City of Portland
Bureau of Development Services
Land Use Services Division

NOTICE OF A TYPE II DECISION ON A PROPOSAL IN YOUR NEIGHBORHOOD

CASE FILE NUMBER: LU 08-131186 DZM – EXTERIOR ALTERATIONS TO MEADER BUILDING TO ACCOMMODATE NEW MAX LINE

Site Plan

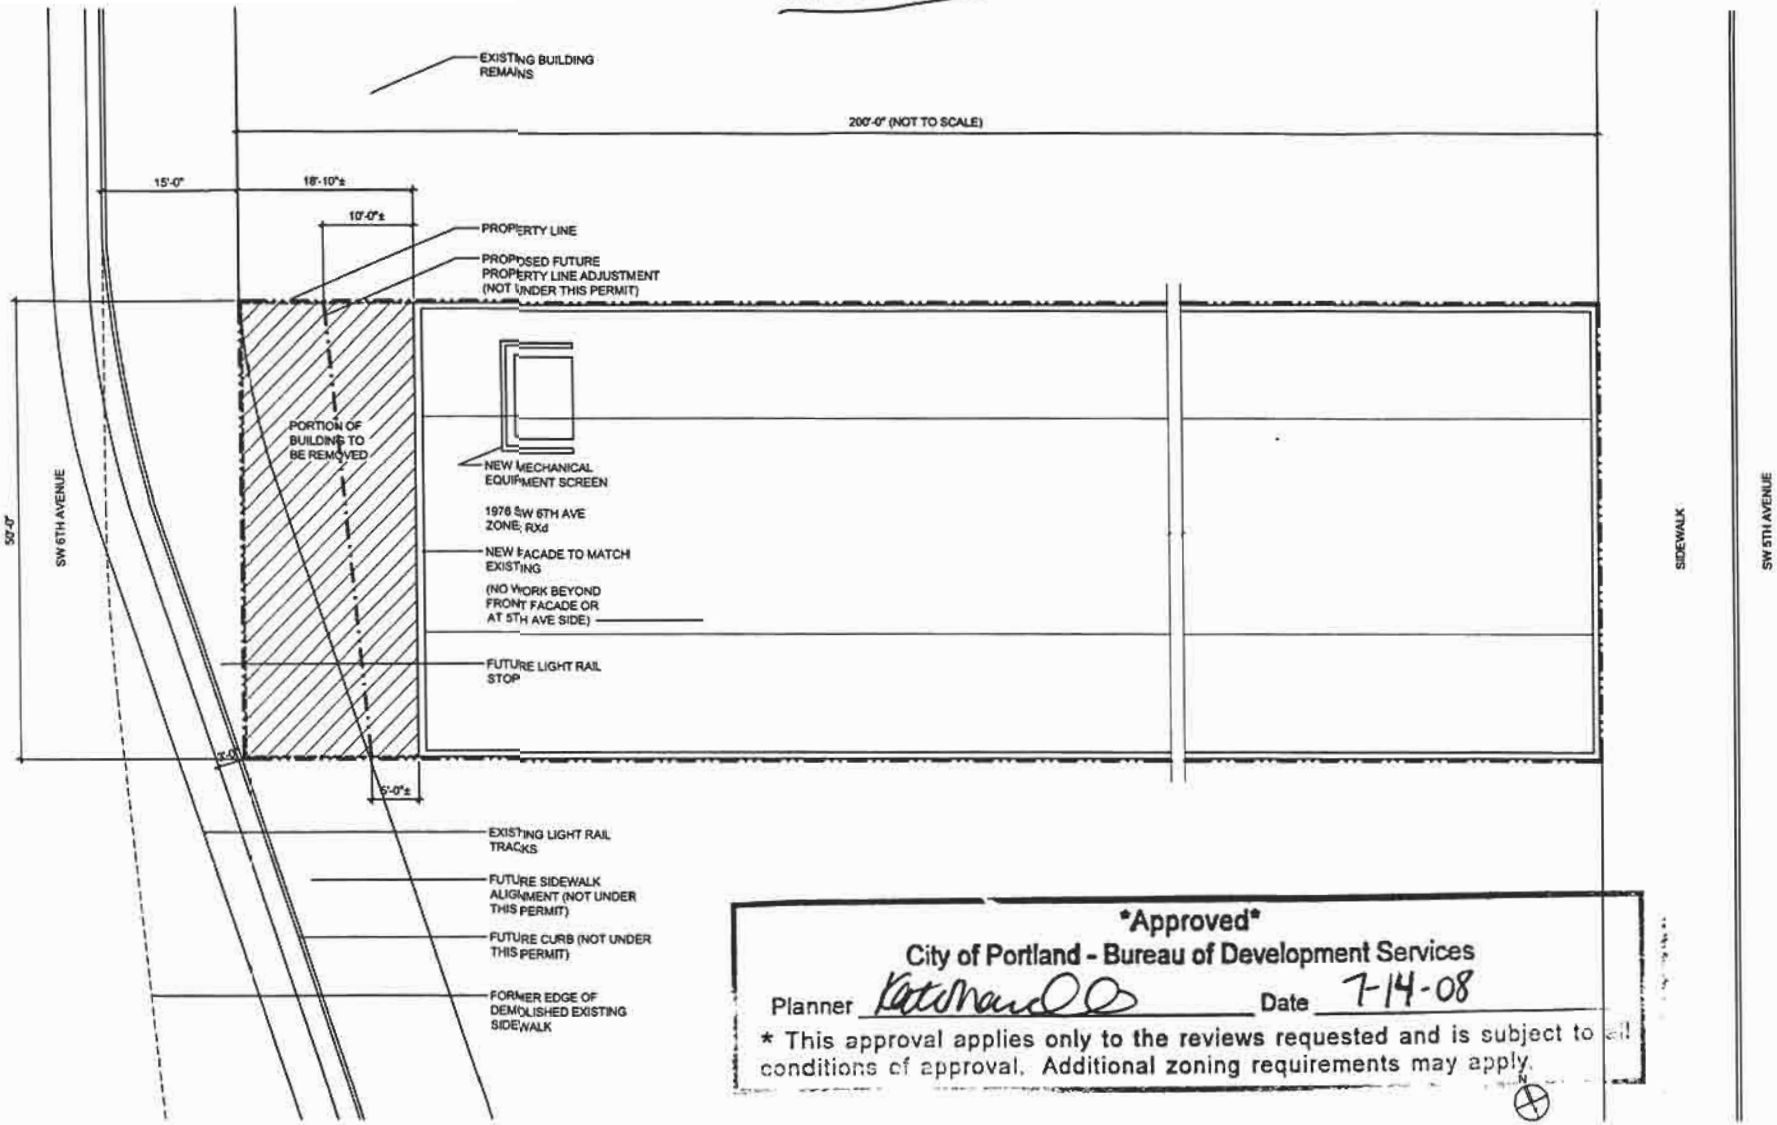
The applicant requests a Modification to *33.120.220, Setbacks*.
The standard states that buildings on designated Transit Streets or in Pedestrian Districts must be set back no more than 10 feet. The applicant is proposing a 34-foot setback between the existing property line and the re-built front façade. (However, a Property Line Adjustment will occur after this Design Review. After the property line is adjusted, the building's set back will be no more than 10 feet from the new property line. Because the Property Line Adjustment will not occur until after the Design Review, the Modification is required.)

Findings: First, the proposal will better meet Guideline *C2: Promote Quality and Permanence in Development*. If the building complied with the setback standard of 10 feet or less from the *existing* property line, there would not be sufficient space for the new public sidewalk to be constructed. The building would be very close to the new curb and MAX alignment. The Transit Mall extension project that is currently under construction depends on continuous public sidewalks for its success and sense of permanence and quality. Conversely, allowing the building to comply with the setback standard of 10 feet or less from the *new* property line (which will be created via a Property Line Adjustment following this Design Review) allows sufficient space for the new public sidewalk, thus accommodating an indispensable element of the Transit Mall extension. A continuous pedestrian connection along the Transit Mall not only promotes the quality and permanence of the Mall itself, it also promotes the quality and permanence of the buildings that abut it. The Mall and the surrounding buildings and sidewalks will create a unique space within downtown Portland; granting the Modification enables the Meader Building to contribute to this endeavor. Secondly, the proposal is consistent with the purposes of *33.120.220, Setbacks*. The building will still maintain light, air, and separation; the general building scale and placement of development in downtown Portland will be maintained; and there will be a reasonable physical relationship among buildings. Most importantly in terms of this particular site, the proposed setback will create an environment that is inviting to pedestrians and transit users.

Approval for Modification to *33.120.220, Setbacks*, to allow a 34-foot setback between the existing property line and the re-built front façade of the Meader Building.

Building Elevation

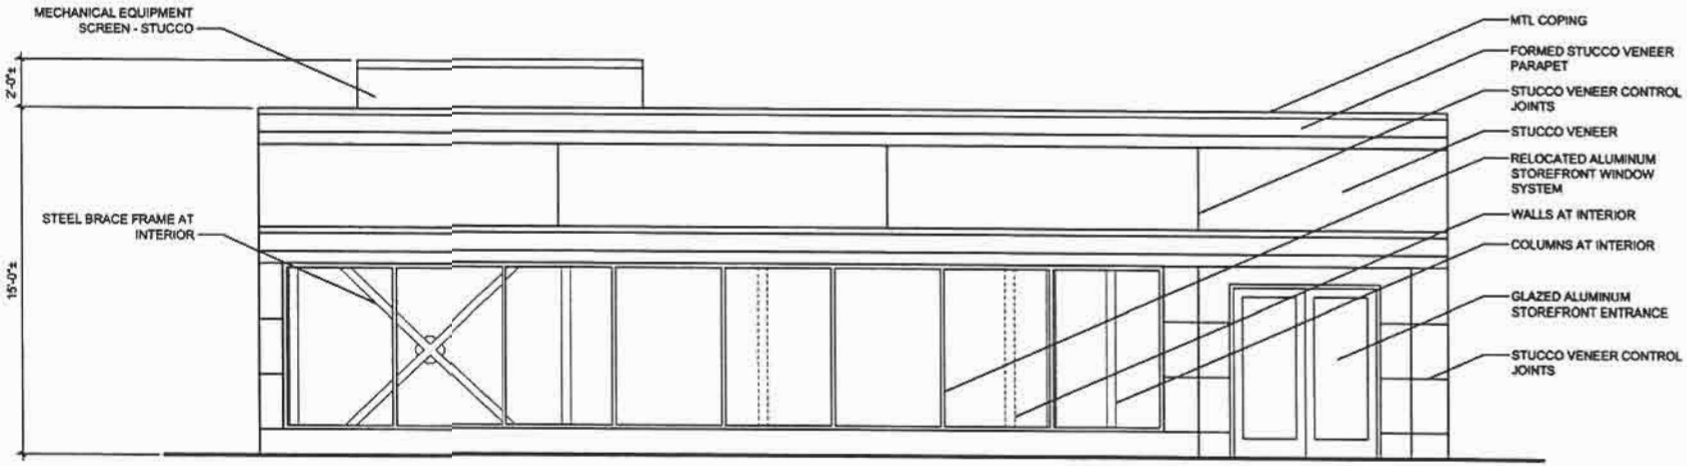
Findings for A4, A5, C4: The local character of downtown Portland includes ground-floor windows, inviting entrances, and human scale, especially along the Transit Mall. The Meader Building will exhibit these qualities. The windows and entry doors will have clear glazing to allow views into the building. Recessed can-lights in the entry area will provide a sense of safety to passersby and building users. A stucco-clad screenwall will shield the existing rooftop mechanical unit from view, ensuring that it does not visually detract from the pedestrian environment along the Transit Mall. The building will positively contribute to the inviting, human-scaled environment that defines downtown Portland. *Therefore these guidelines are met.*

Findings for C2, C3, C5: The proposal uses high-quality materials and respects the architectural integrity of the existing building. The façade will be re-built to look effectively the same as the existing façade. In fact, the existing aluminum-framed windows and entry doors will be re-glazed and re-used. The two existing light fixtures are deteriorated and will be replaced with updated fresnel-lens fixtures. The new façade will have a stucco veneer with jointing similar to the existing façade. The screenwall that shields the rooftop mechanical unit from view will be clad in stucco and painted to match the front façade of the building. The re-built front façade, with its row of storefront windows, jointing in the stucco veneer, and strong cornice line, will retain the horizontal orientation that characterizes the front of the Meader Building. The building's elements are integrated with one another to form a coherent composition. *Therefore* these guidelines are met.

Approval to rebuild the front façade of the Meader Building by removing the front 18 feet 10 inches, install new recessed light fixtures at the main entrance, and install a stucco-clad screenwall around the north, south, and west sides of the existing rooftop mechanical unit.

Section

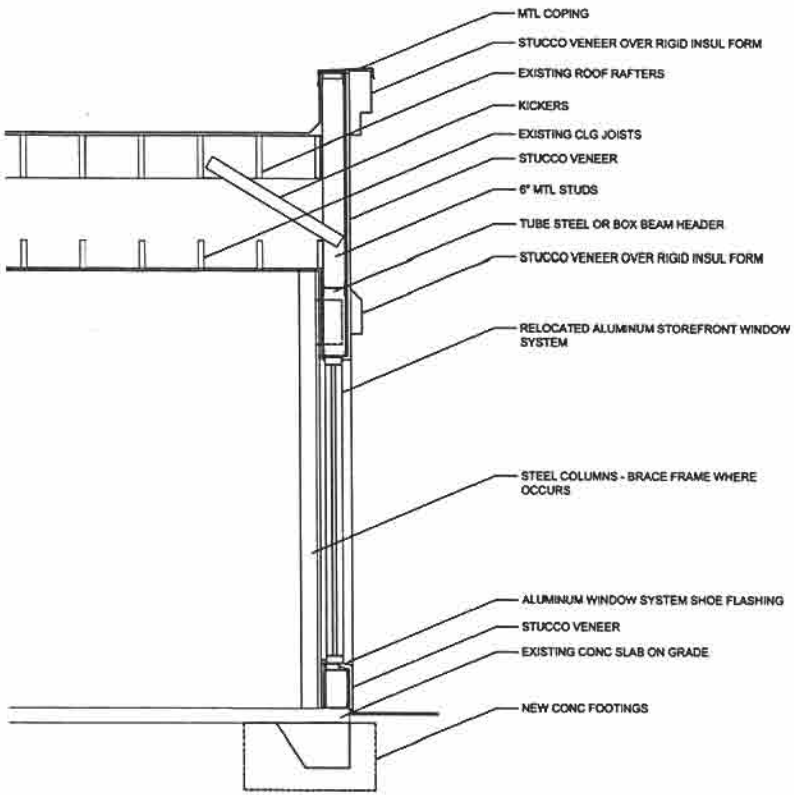
Findings for C11: There is an existing rooftop mechanical unit on the building. Currently it is about 29 feet 10 inches from the western roof edge and 5.25 feet from the northern roof edge. After the front façade of the building is moved back 18 feet 10 inches, the existing unit will be located approximately 11 feet from the western edge. The unit is 6'-3" long x 4'-6" wide x 4'-0" tall. The existing parapet on the building is about 2 feet tall, so the total height of the unit above the parapet is 2 feet. A 2-foot-tall stucco-clad screenwall will shield the unit from view. The screenwall be installed around all sides of the unit except for the rear, which faces the interior of the block. The screenwall will match the building façade in both color and materials, thus appearing as an integrated element of the building's design. When viewed from adjacent taller buildings, the mechanical unit will appear unobtrusive, as it is the sole unit on the rooftop and it is oriented orthogonally to match the orthogonal form of the rooftop. *Therefore this guideline is met.*
